Southend Sweater Co Ltd (Extension)

06 February 2025

3. Observations:

Observation-1: Design report needs to be reviewed against lateral forces (Main Factory Building).

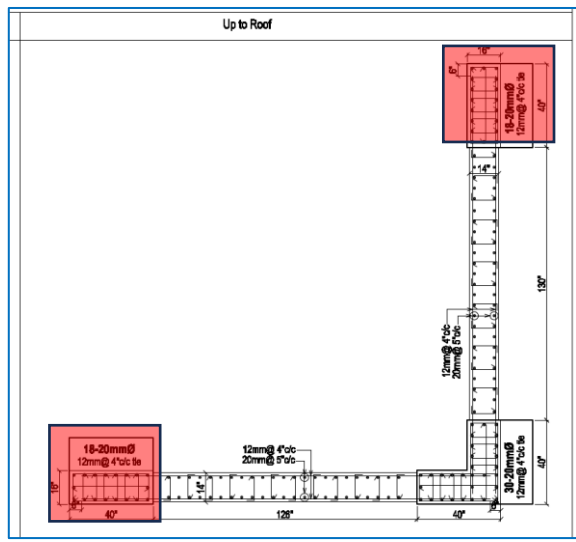
Description: A design report has been prepared for the ten Main Factory Building. The prepared design report needs to be reviewed against lateral forces. Submit the design report to the RSC for detailed review.

Item No	Observation	Action Plan	Timeline
1.	Design report needs to be reviewed against lateral forces (Main Factory Building).	The building engineer is required to revise the design report as per updated drawing and submit it to RSC for review against lateral forces.	within 6 weeks

Observation-2: Mismatch between drawing & onsite condition (Main Factory Building).

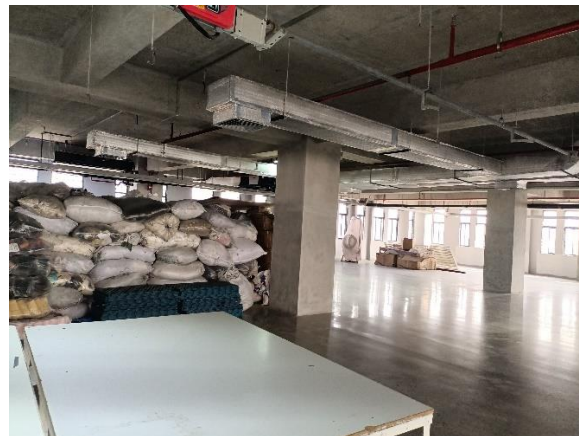
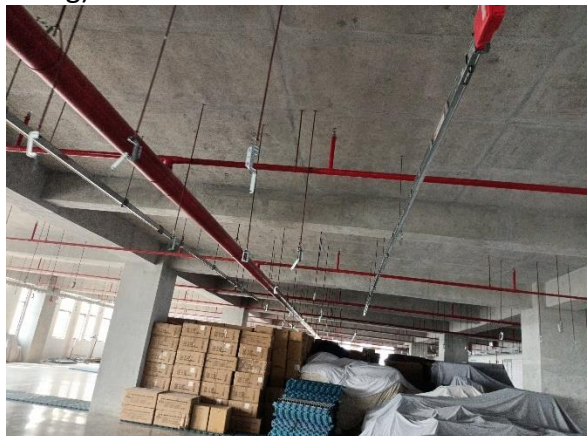
Description: Amount of rebar at shear wall head of SW1 (South) did not match with drawings. In long face 7 nos rebar was found instead of 8 nos. The building engineer is required to update the drawing based on the as-constructed structure.

4.	Mismatch between drawing & onsite condition (Main Factory Building).	The building engineer is required to update the drawing to the as-constructed status.	within 6 weeks
